CITY OF BEAVERTON
DESIGN EXCEPTION REQUEST

Curb Return Radii Design Exception Request – Additional Information

Horizontal Alignment Design Exception Request – Additional Information

SW DENNEY ROAD
 SW 105TH AVE TO SW SCHOLLS FERRY ROAD
 WASHINGTON COUNTY

TRUCK TURNING EXHIBIT SW DENNEY RD BEAVERTON, OREGON	SHEET NO. 1 OF 1 JOB NO. WAS-39
---	--

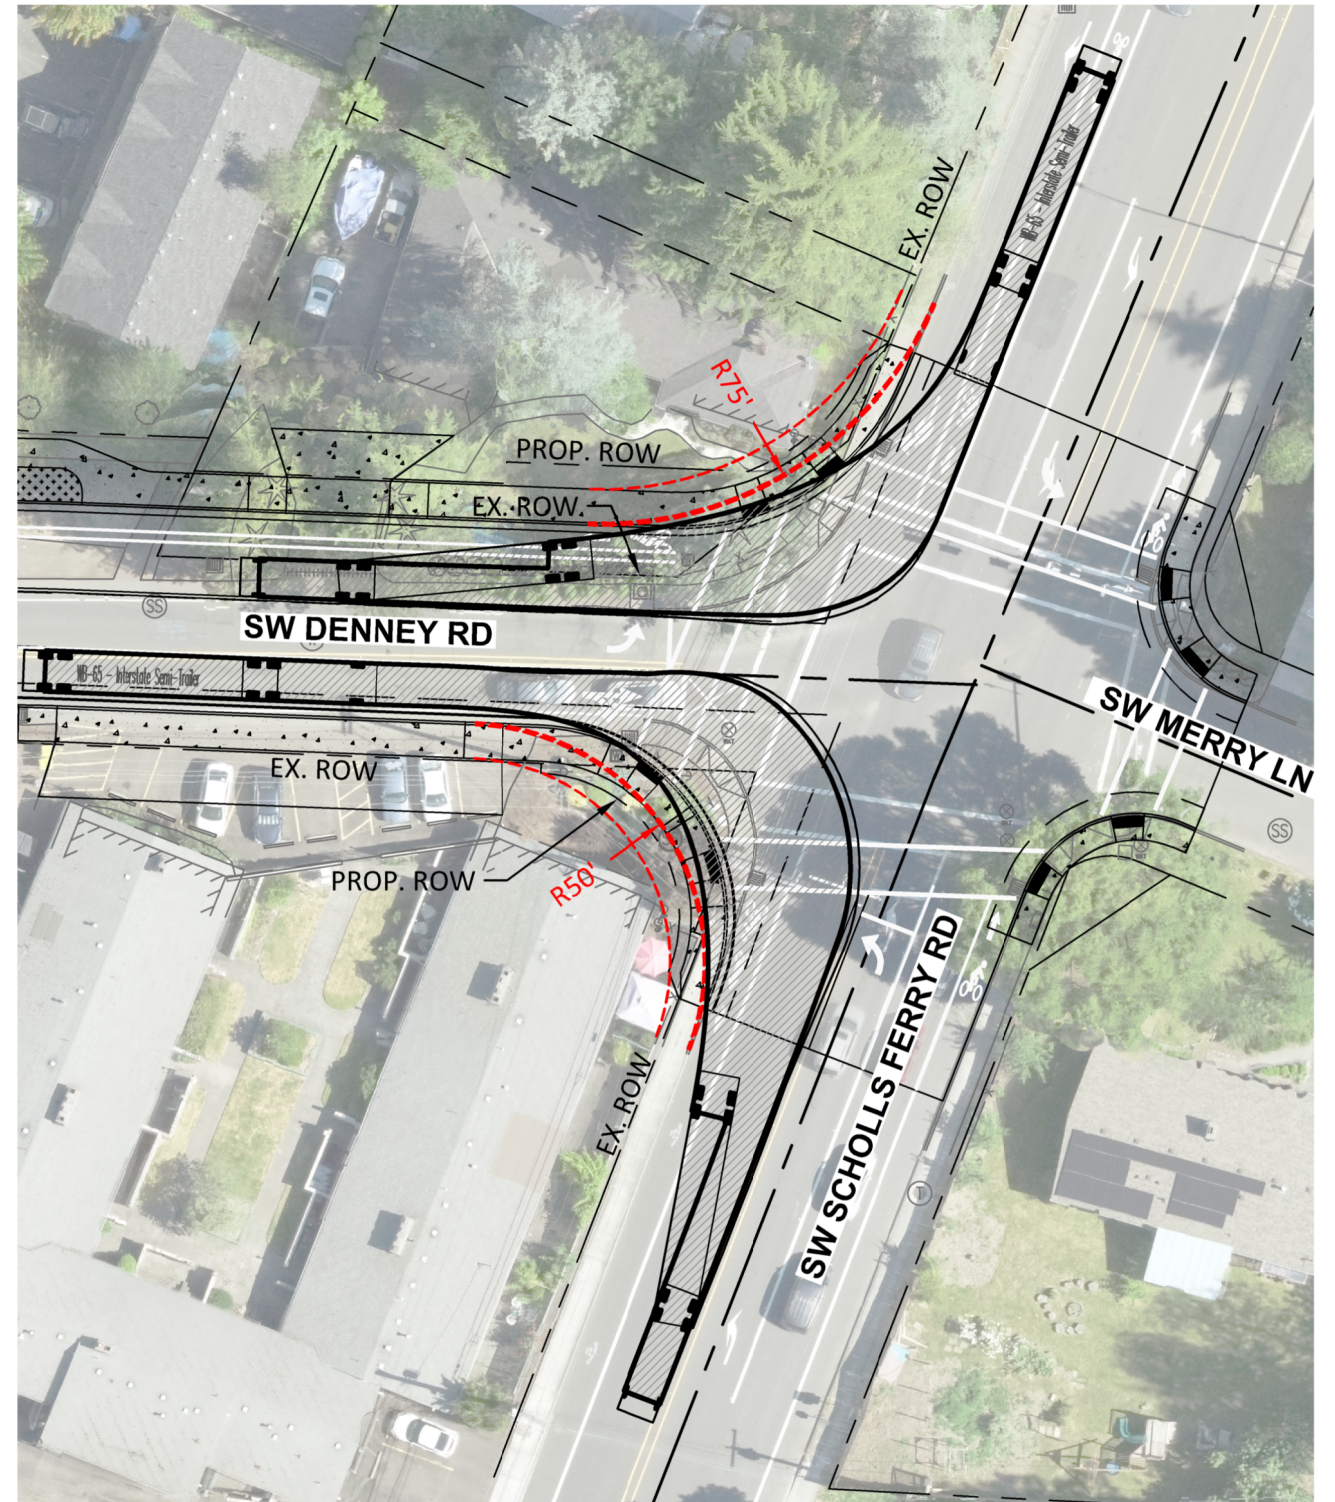
Reason For Not Attaining Standard: The primary reason for not meeting the standard is the impact larger curb radii would have on the adjacent properties. Per section 210.19 of the Engineering Design Manual, the intersection of SW Denney Rd and SW Scholls Ferry Rd must accommodate a WB-65 Interstate Semitrailer Design Vehicle because SW Scholls Ferry Rd is designated as a Truck Route in the Comprehensive Plan Transportation Element. To accommodate a WB-65, the northwest corner of SW Denney Rd and SW Scholls Ferry Rd would have a curb radius of 75' and the southwest corner of SW Denney Rd and SW Scholls Ferry Rd would have a curb radius of 50'. These larger curb radii would require additional right of way acquisition and would impact existing structures, likely requiring the purchase of two residential properties. Larger curb radii would also increase the pedestrian crossing distance making the intersection less safe for pedestrians. See the attached Truck Turning Exhibit for details for a comparison of the proposed design to the footprint needed to meet the design requirement.

The NW and SW corners of SW Denney Rd and SW Scholls Ferry Rd currently have radii of 45' and 25' respectively. The proposed design utilizes a curb radius of 50' at the northwest corner of SW Denney Rd and SW Scholls Ferry Rd, and a 40' radius at the southwest corner to accommodate a right turning movement of a WB-50. This significantly improves vehicle maneuverability through the intersection while keeping impacts to adjacent private properties to a minimum.

DESIGN PROPOSED TO ACCOMMODATE A WB-50 VEHICLE

DESIGN REQUIRED TO ACCOMMODATE A WB-65 VEHICLE

SHEET NO.
34 OF 84

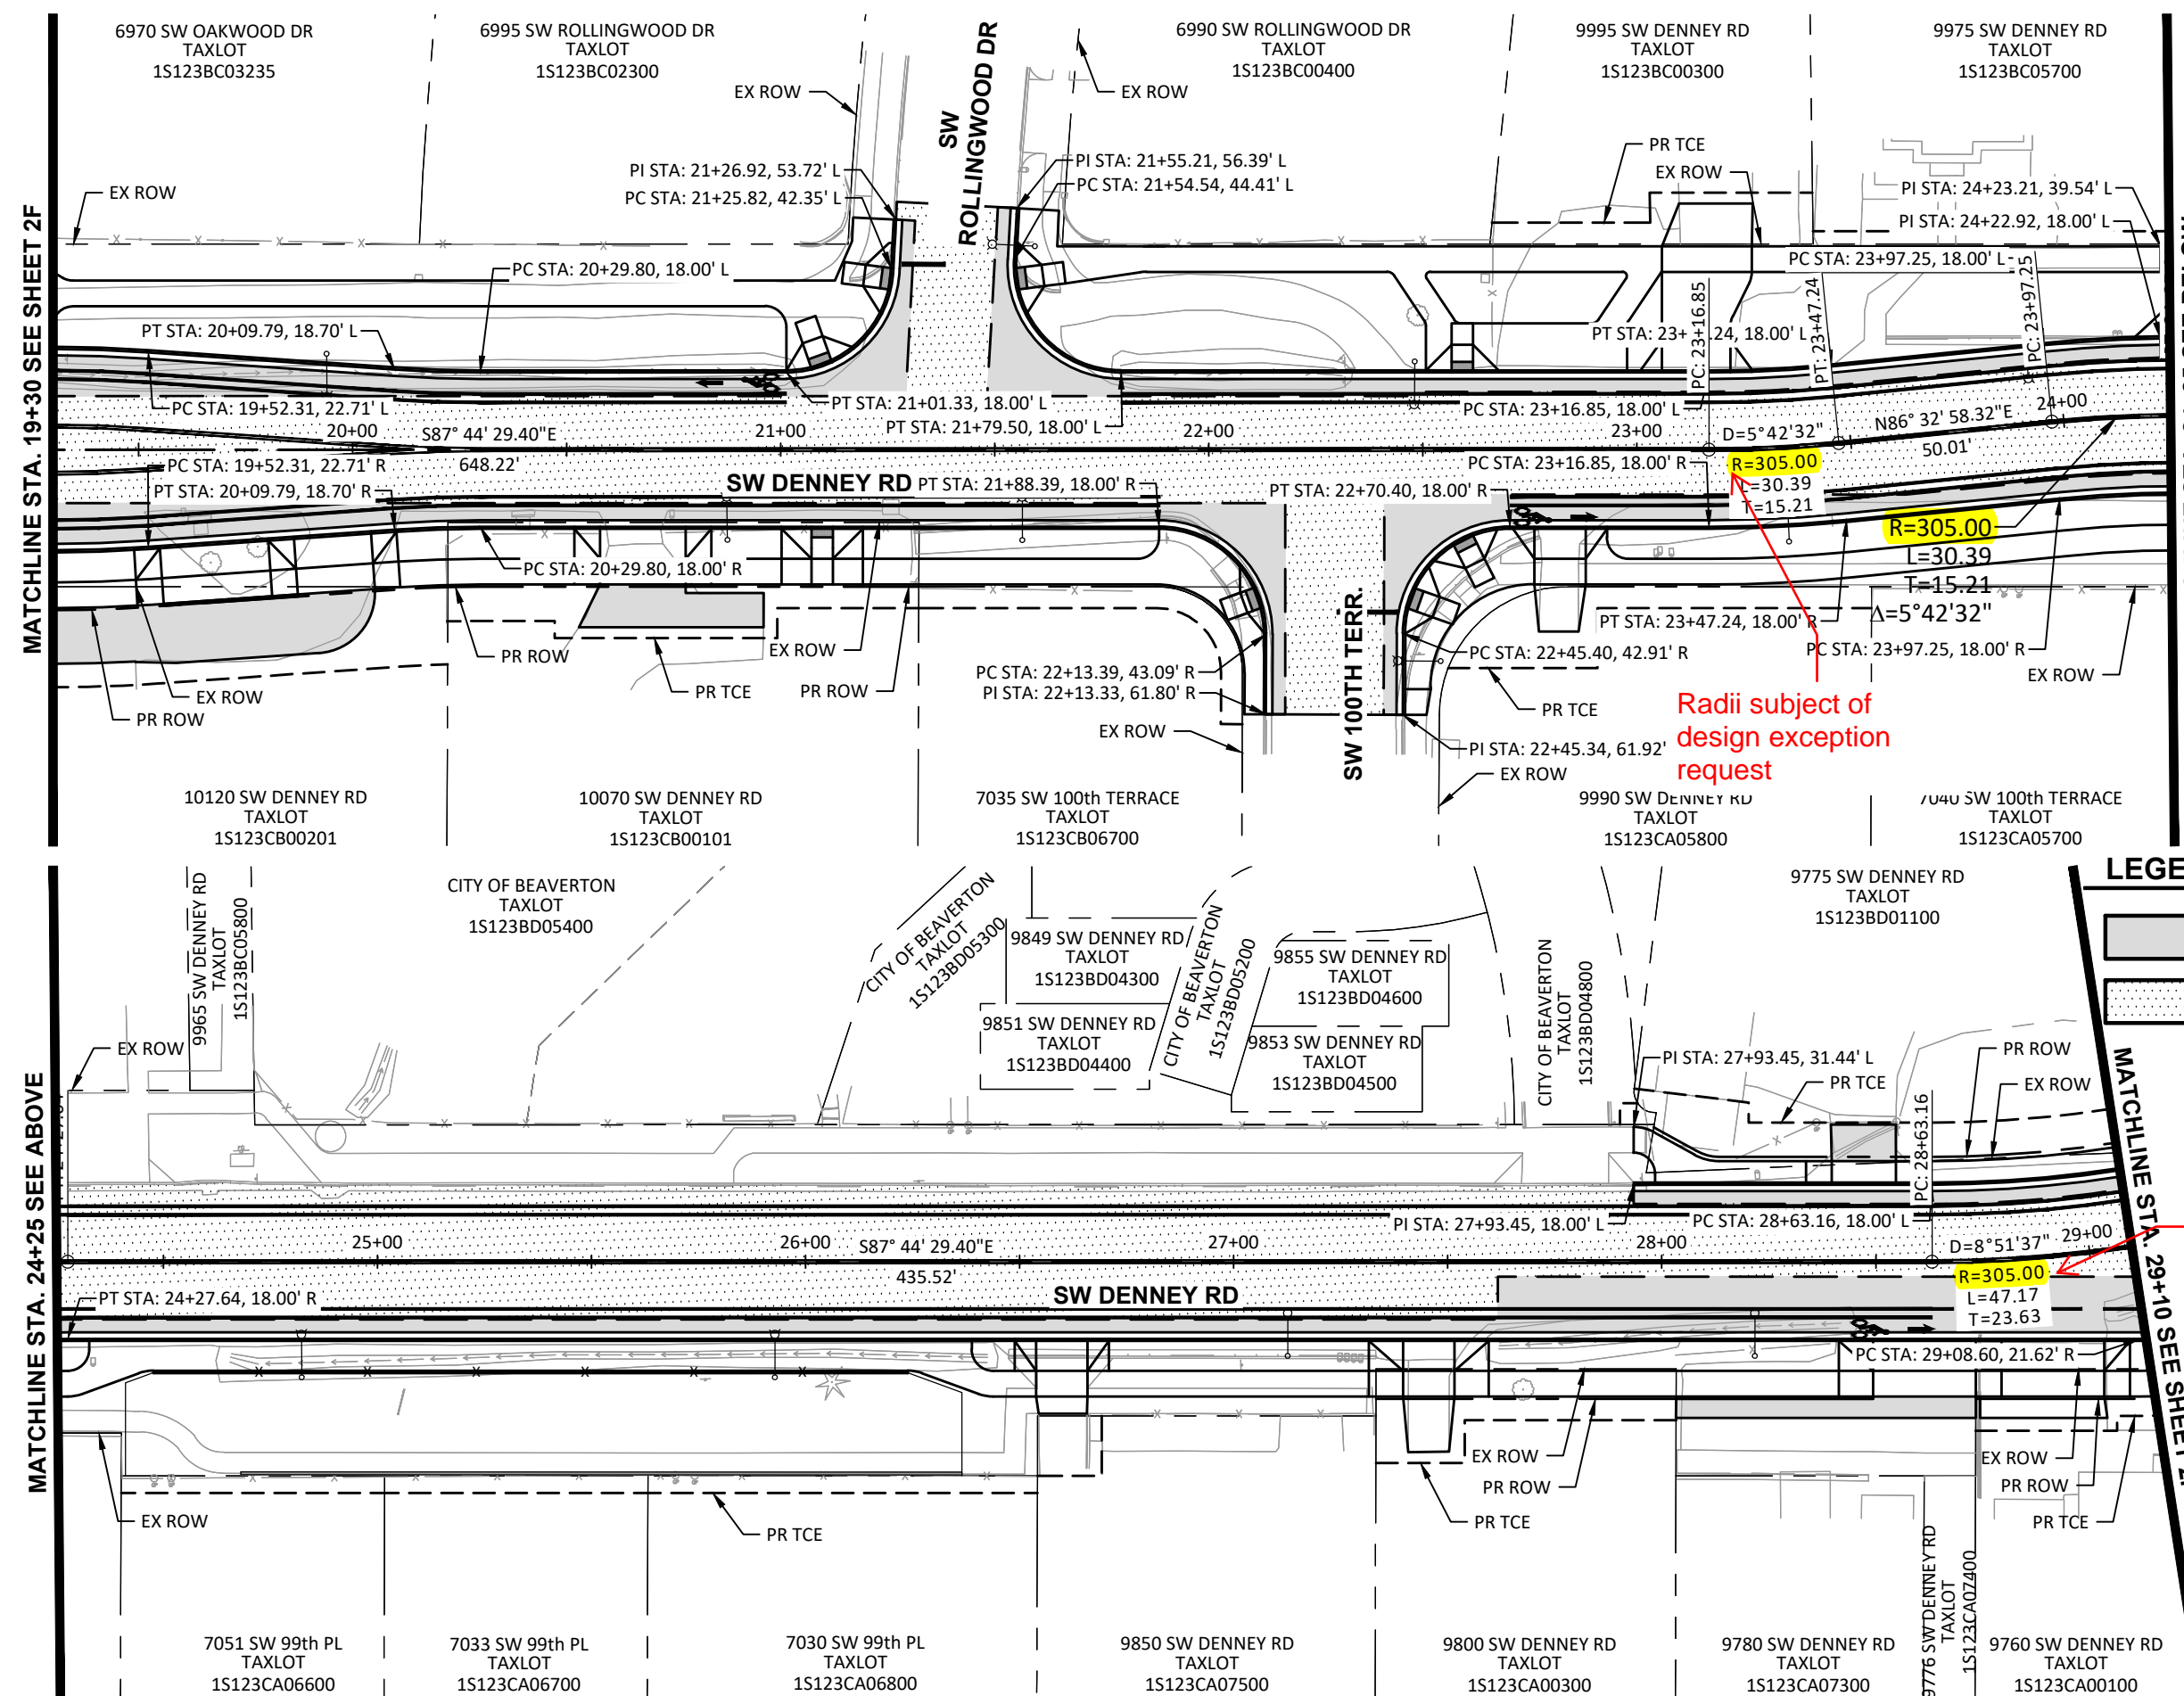
Radius subject of design exception request

SHEET TITLE
2F-2

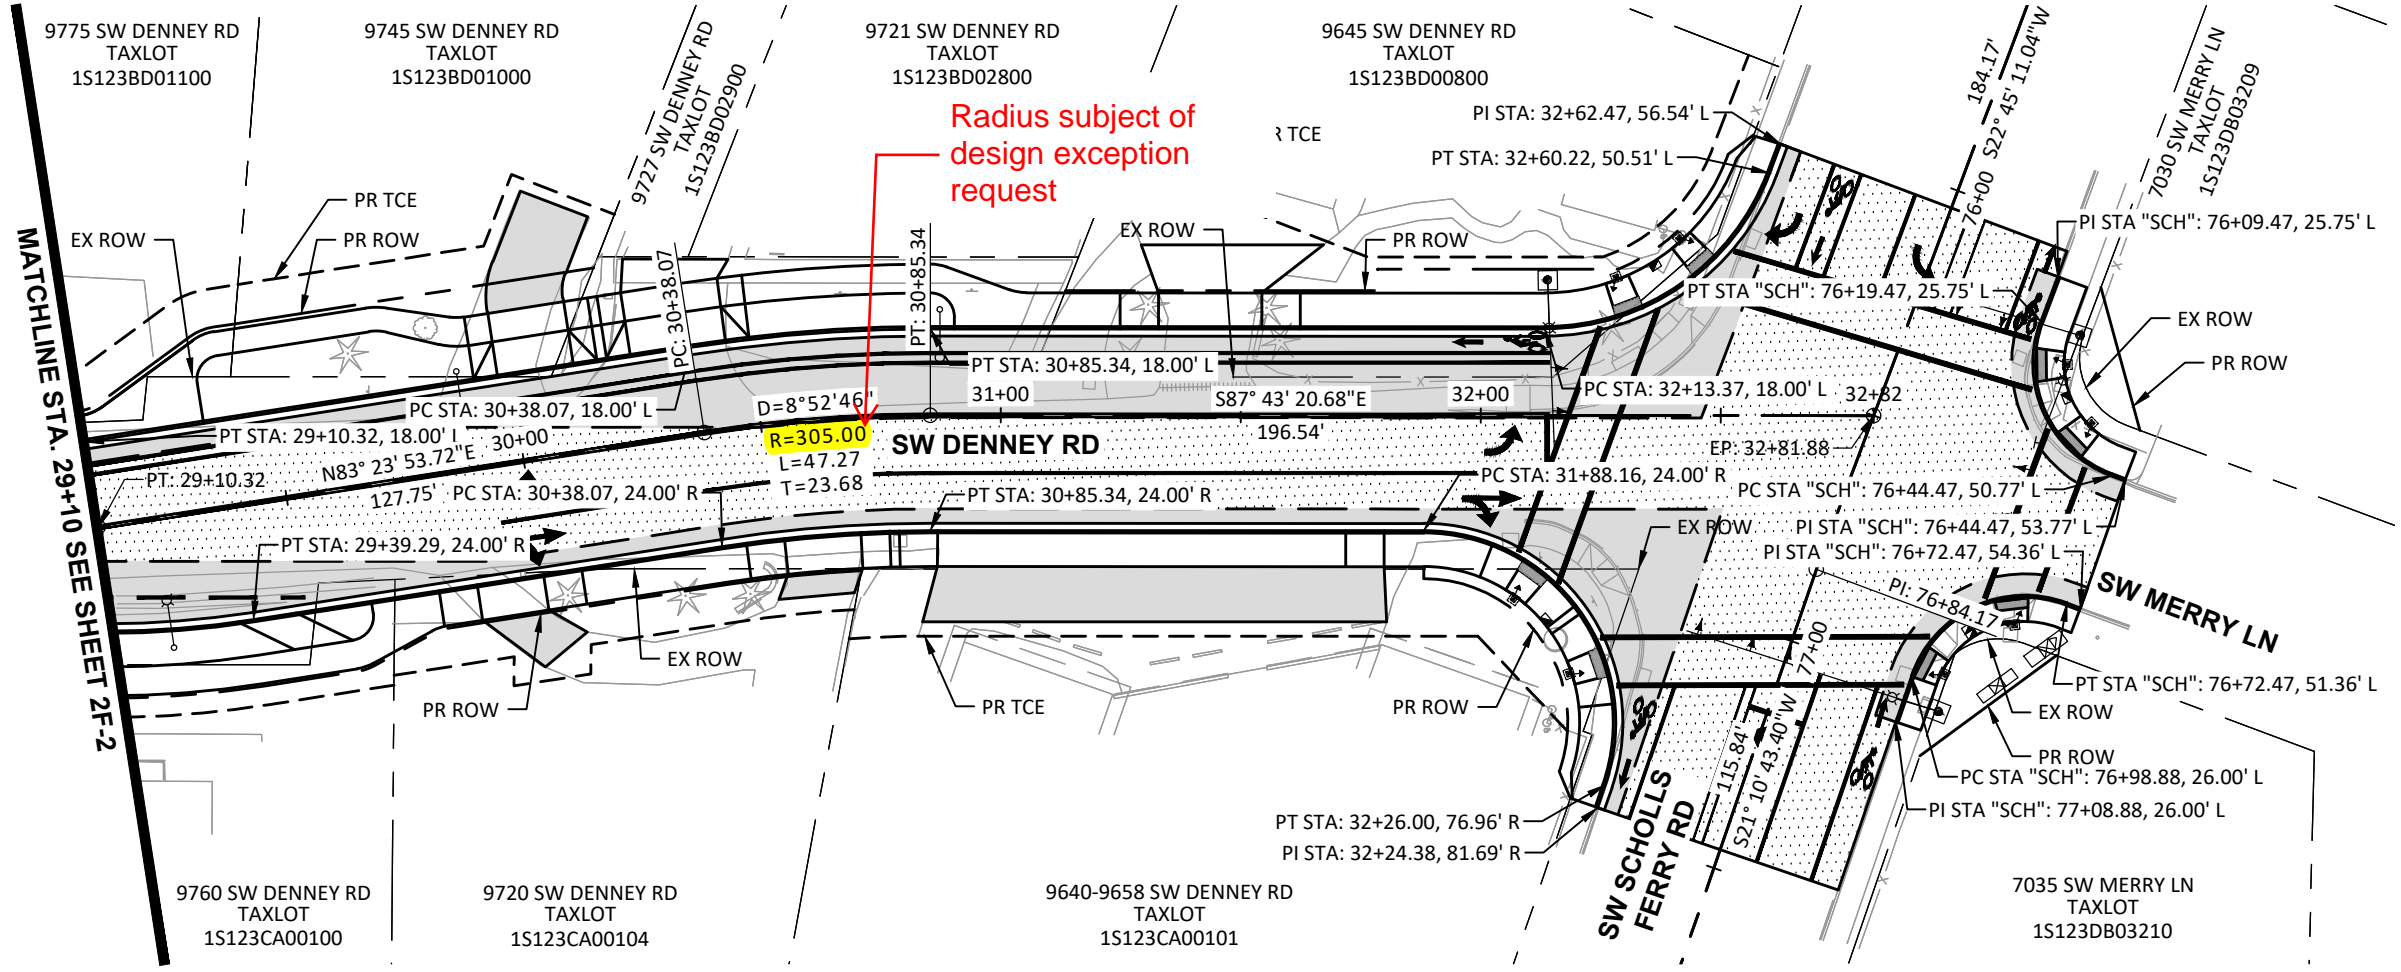
Reason For Not Attaining Standard: The primary reason for this design exception request is that a smaller centerline radius allows for the protection of more significant trees and private improvements, which has been a priority for this project. Utilizing a minimum CL radius of 475' would increase the length of the transition, pushing it closer to the intersection of SW Scholls Ferry Rd reducing the available queuing length, while also pushing further west requiring the removal of several high priority trees.

To reduce impact on trees, private improvements, and encourage reduced vehicle speeds, the design team selected a minimum CL radius of 305 feet based on table 210.10 of the Engineering Design Manual. This corresponds to a design speed of 30 mph. While the design speed of SW Denney Rd is 35 mph, design criteria based on a lower speed is justified based on the nature of the roadway and the posted speed limit of 30 mph.

The CL transition between Sta. 28+63.16 and 30+85.34 has the greatest horizontal shift of the two CL transitions that utilize a radius of 305', at 27', but is near the signalized intersection of SW Denney Rd and SW Scholls Ferry Rd. Vehicle speeds are expected to be lower than the posted speed through these curves at vehicles approach or exit the intersection.

Radius subject of design exception request
